SYDNEY OLYMPIC PARK AUTHORITY

Planning Assessment Report

Application No:	DA 03-02-2020
Application Site:	3-5 Olympic Boulevard, Sydney Olympic Park, 2127
Proposal:	Alteration to level 39 and level 40 to provide roof access for maintenance
Applicant:	Ecove Site 9 Pty Limited
Determining Agency:	Sydney Olympic Park Authority

Figure 3 – Level 40 floorplan showing location of the stair. Indicative location of balustrade in green.

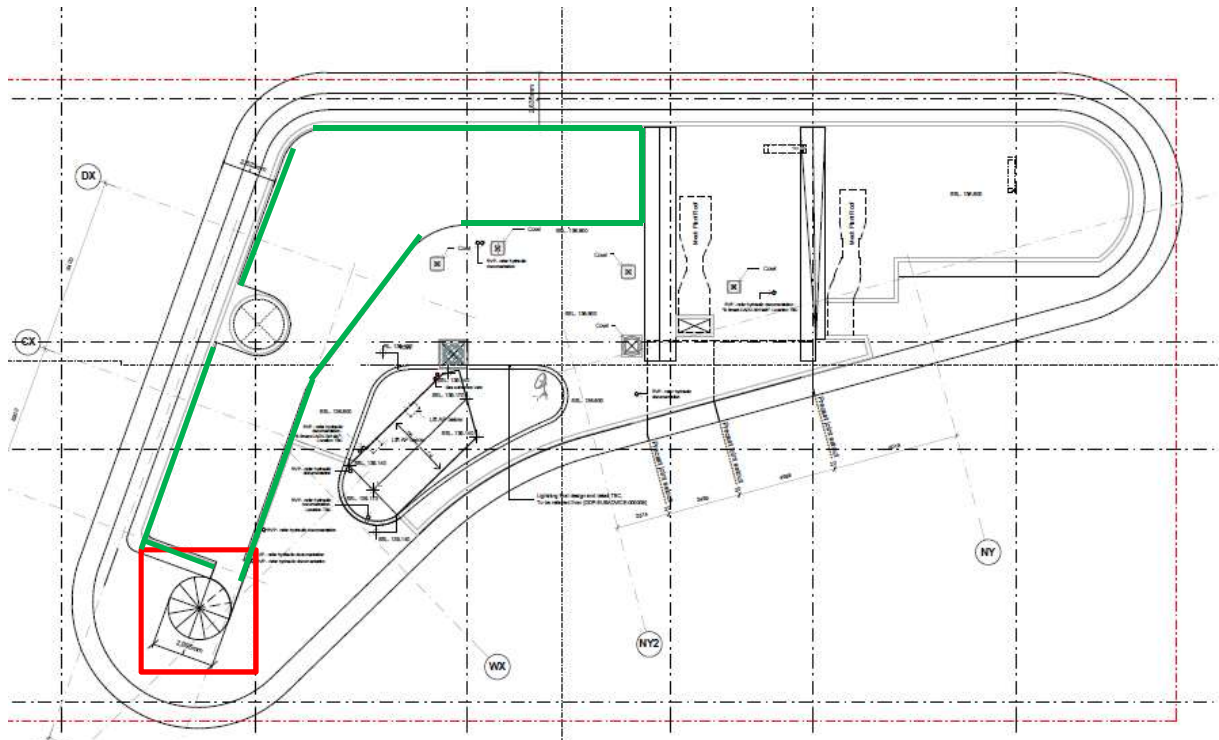
(29) Development within an environmental conservation area	The site is not located within a conservation area.	✓
(30) Design Excellence	Whilst the staircase and balustrade are of a utilitarian design, it is considered they will not detract from the overall design excellence of the host building. The balustrade will be constructed out of clear glass at a height of 1.2m and will not be visible from the ground level. The glazing will be in-keeping with the design approach to the upper level of the building which comprises a recessed glazed balustrade to the parapet level of the building. The stair will be set back from the parapet and will not be visible from ground level.	✓

By virtue of the siting, setback and location of the proposed stairs, the works will not detract from the design quality of the building and will not be visible from the surrounding public domain.

The rooftop balustrade is not out of character for a residential tower such as this. The balustrade, by virtue of its location and construction of clear glazing will not detract from the design quality of the existing building. Overall, it is considered that the proposal will have negligible impact on the design quality of the existing building and complies with the objectives and controls contained within the Master Plan 2030 (2018 Review).

It is proposed to impose a condition restricting the use of free-standing furniture and other unsecured objects on the rooftop to ensure that the development does not introduce a hazard for pedestrians or property or the ability for the balustrade to be climbed onto.

Figure 4 – Plan showing access to the stair which will be controlled by a balustrade from the garden space of the penthouse apartment.

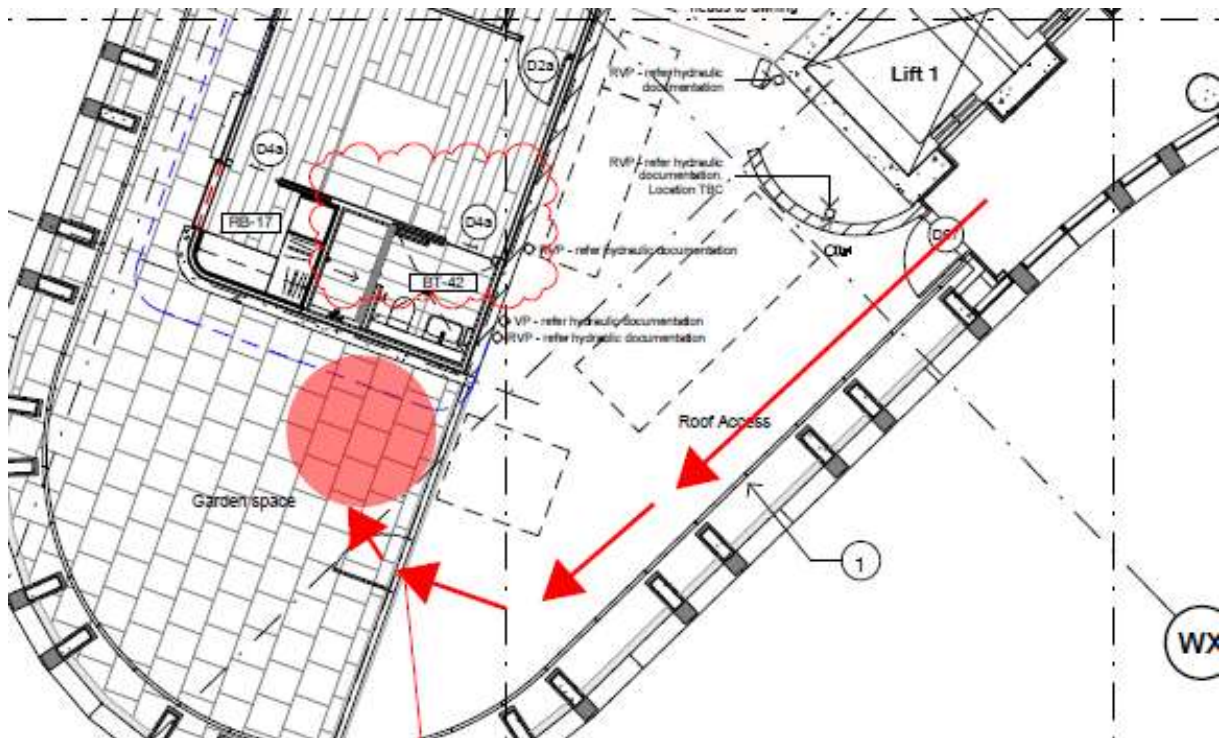
The stairway will be accessed through an existing fire escape onto the roof which does not form part of this DA. The staircase will be cordoned off by a balustrade for access and maintenance.

On 16 March 2020, a letter was issued pursuant to section 54 of the EP&A Act requesting the submission of further information relating to the approved roof plan, access and balustrade details. Further information was submitted by the proponent on 3 April 2020 in relation to access and egress.
